Service Bulletin

Maintenance of Way Equipment

RRP Service Bulletin No: RRP SB356

Product Series: Advance Tie Plate Inserter [ATPI]

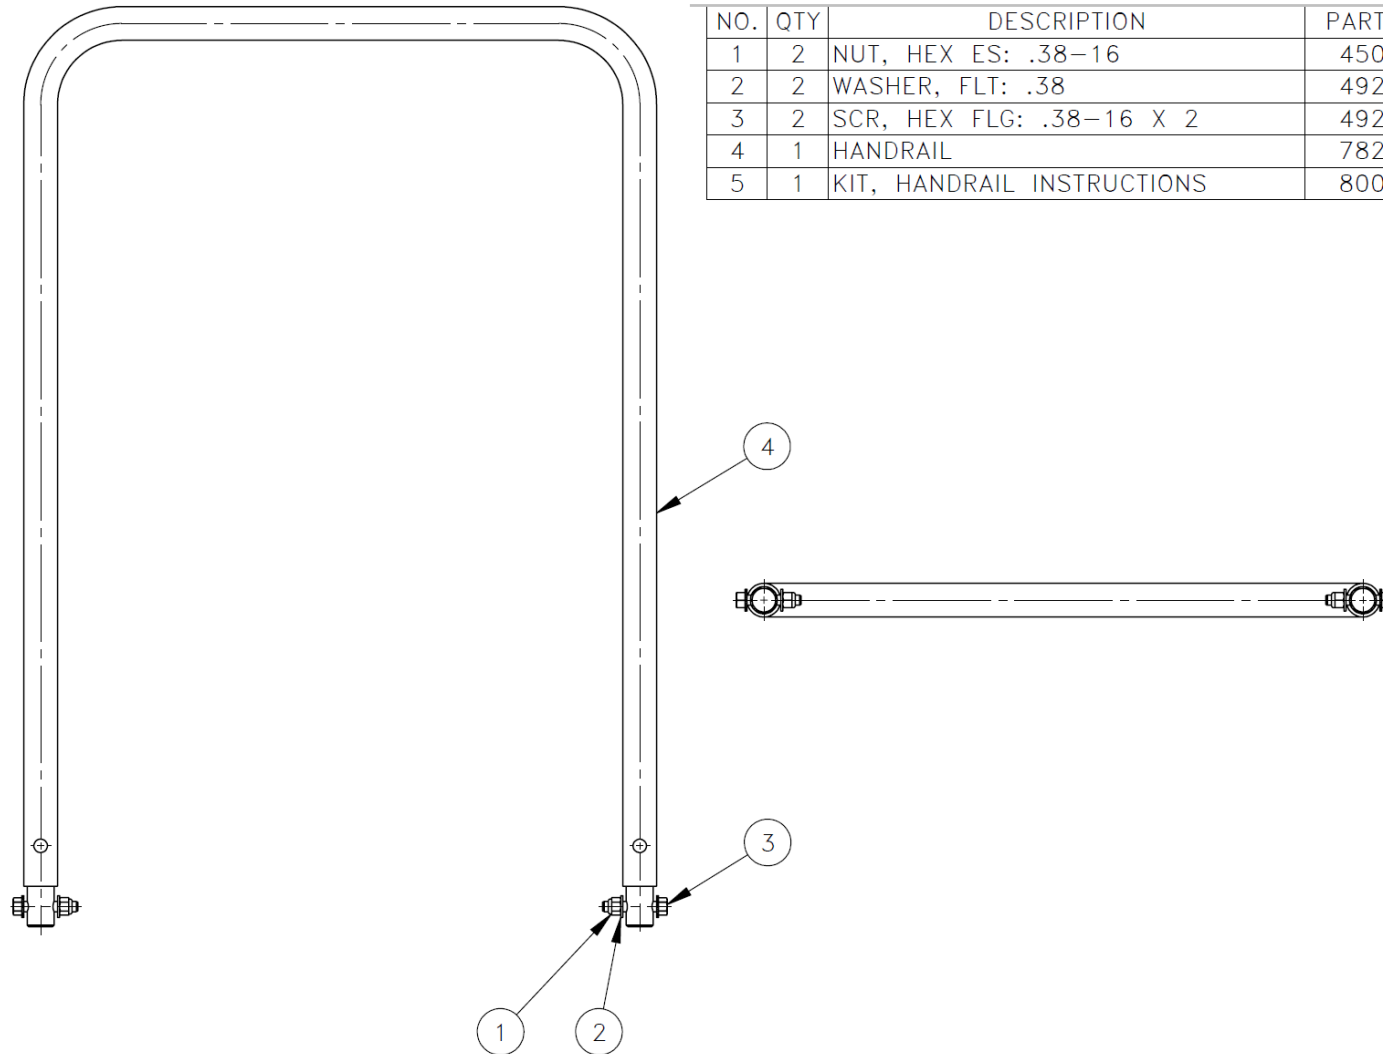
APTI units have defective handrails. Use Service Kit 793094 to replace handrails.

Replace Handrail with RRP Kit # 793094

Continue with normal machine operation after replacing the handrails.

Instructions:

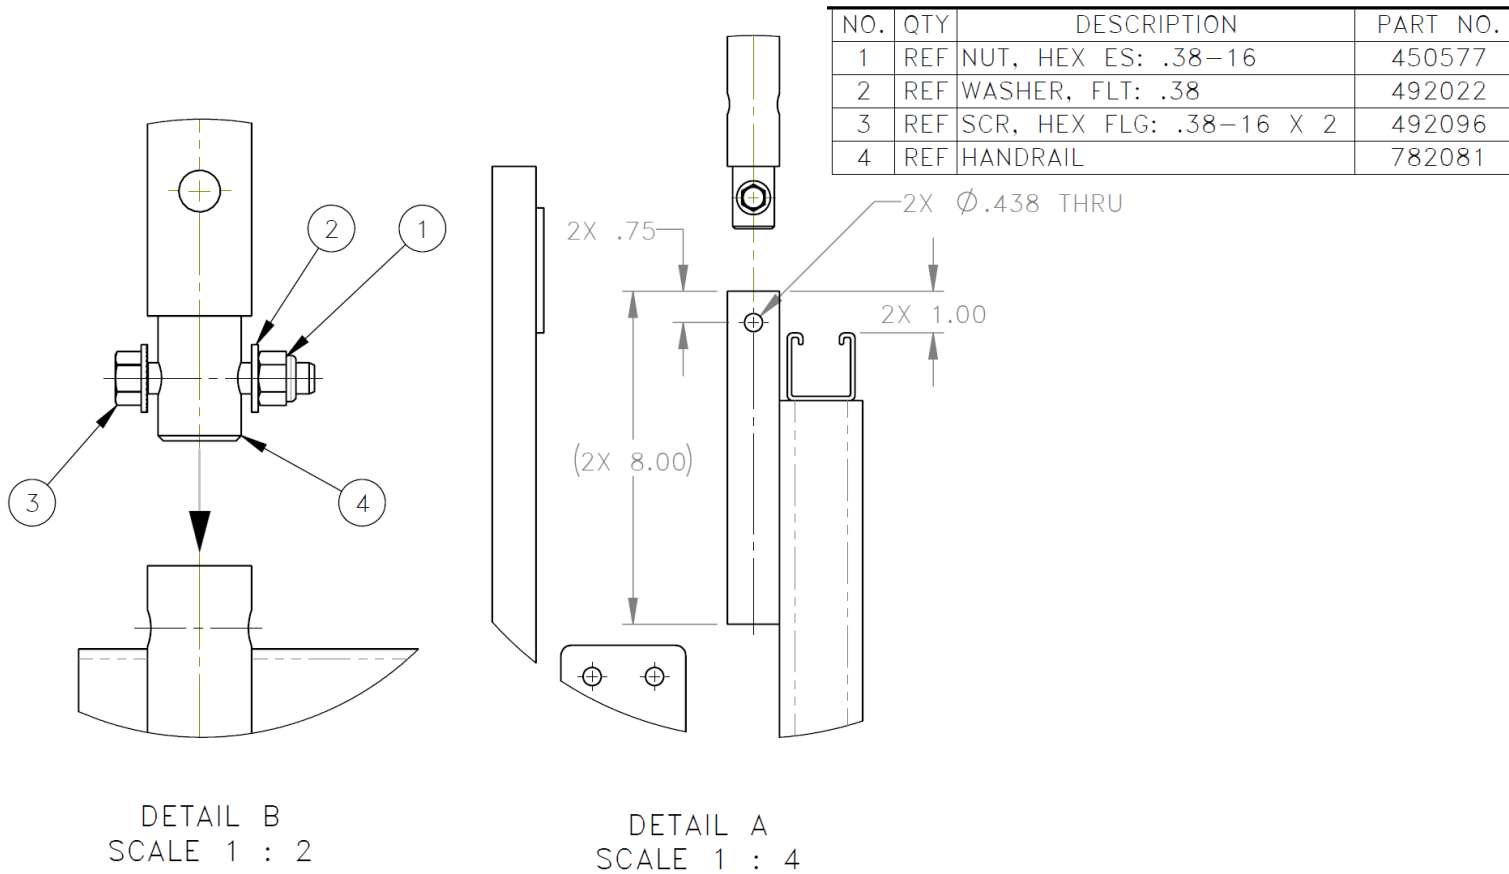
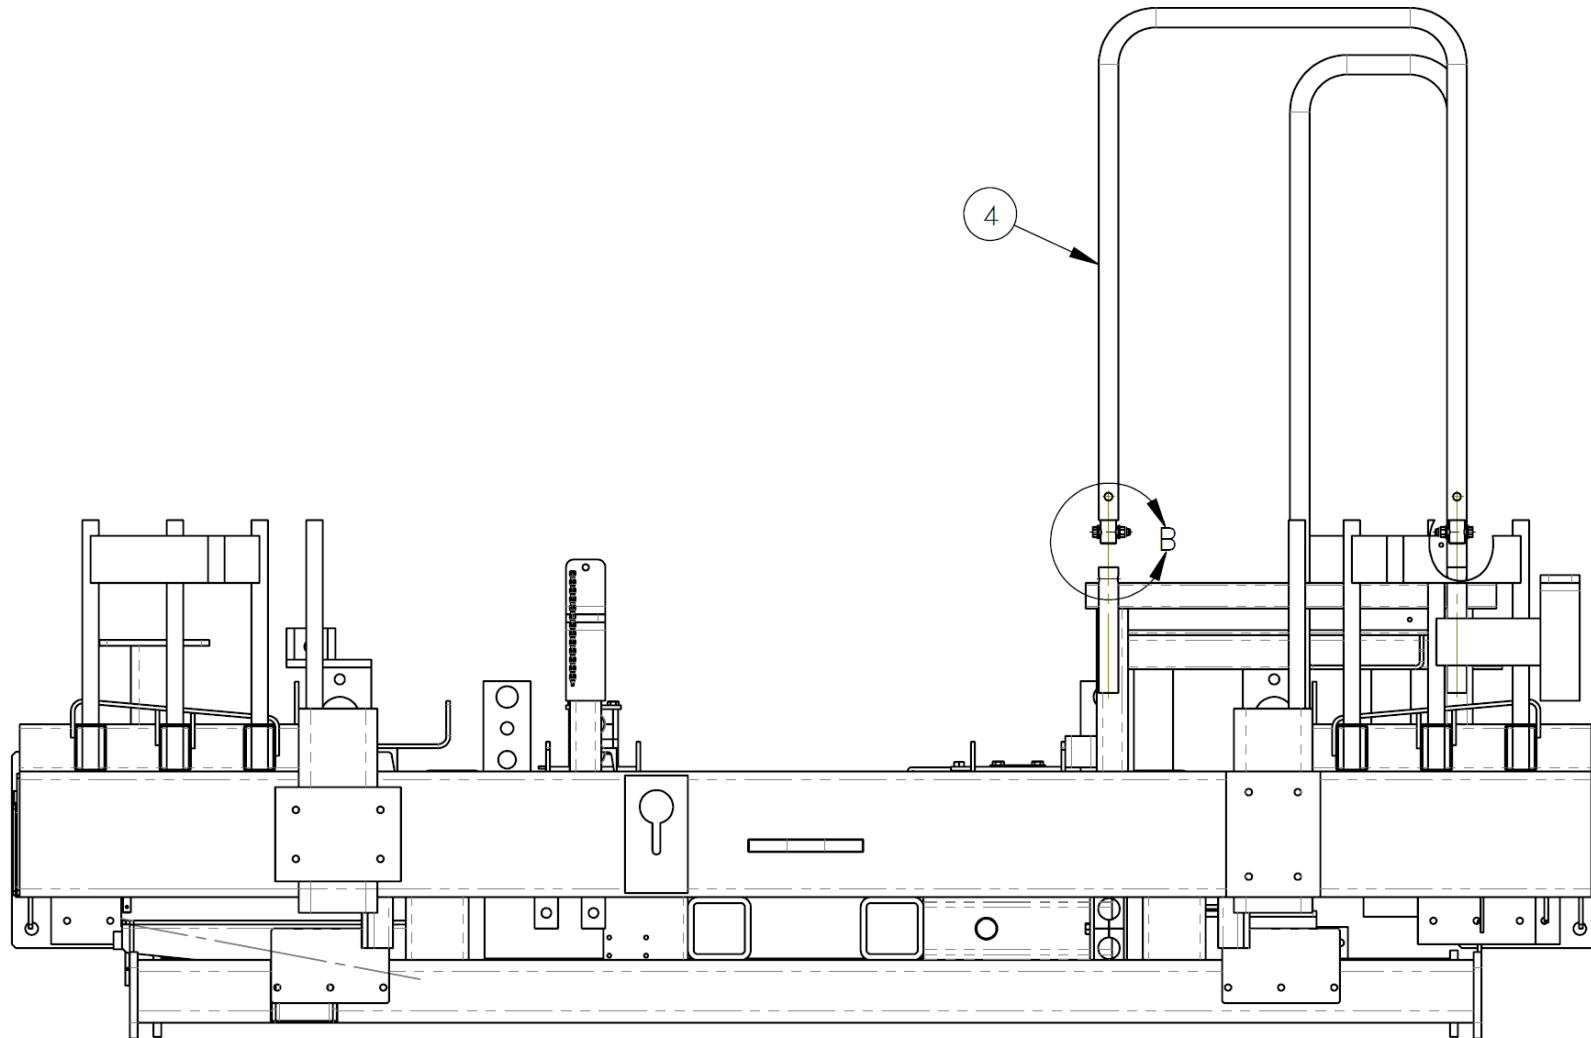
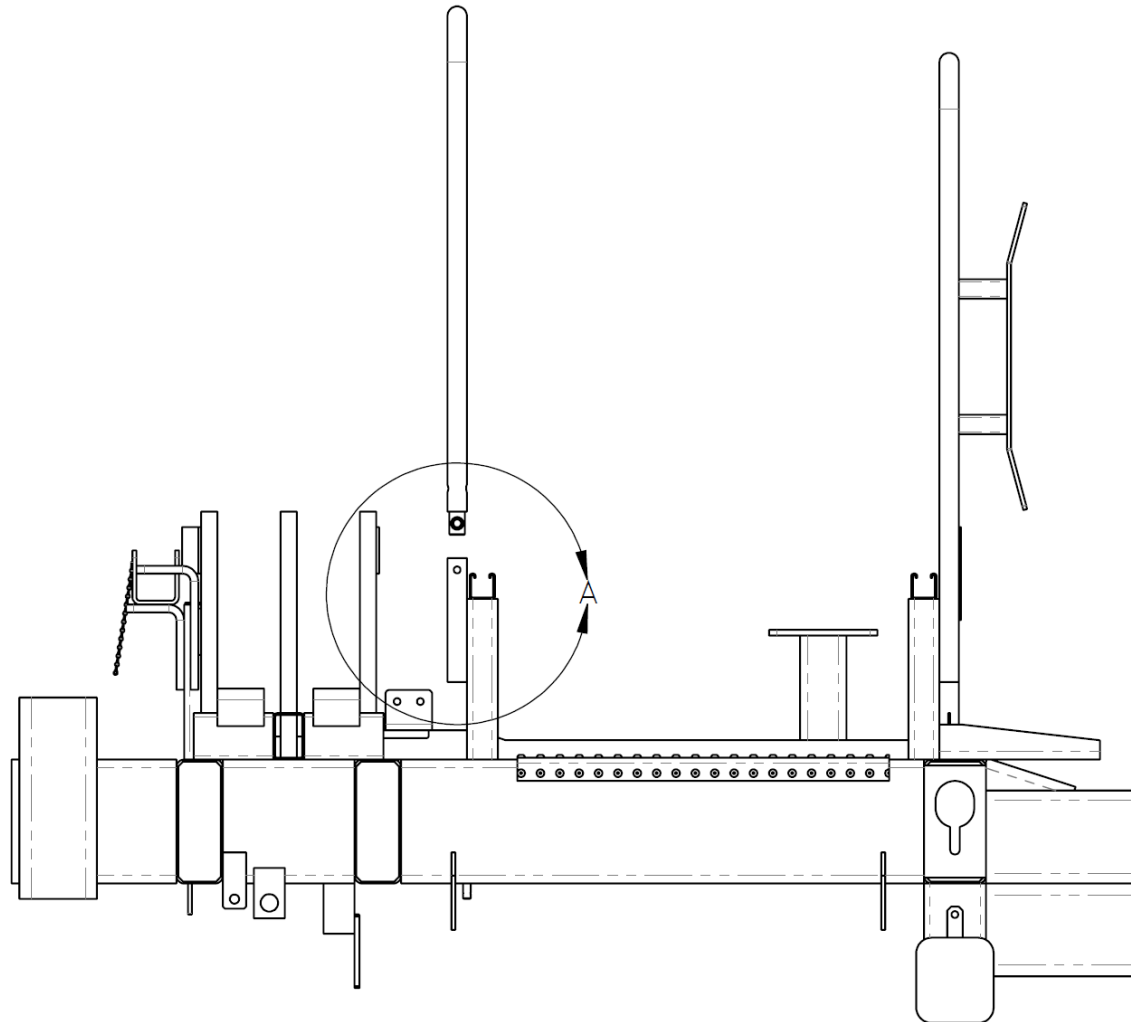
1. Cut off original handrail. See Detail A
2. Drill $\varnothing.438$ holes thru both tubes. See Detail A
3. Insert handrail into cut off tubes.
4. Install and tighten bolts, washers and nuts as shown on Detail B.
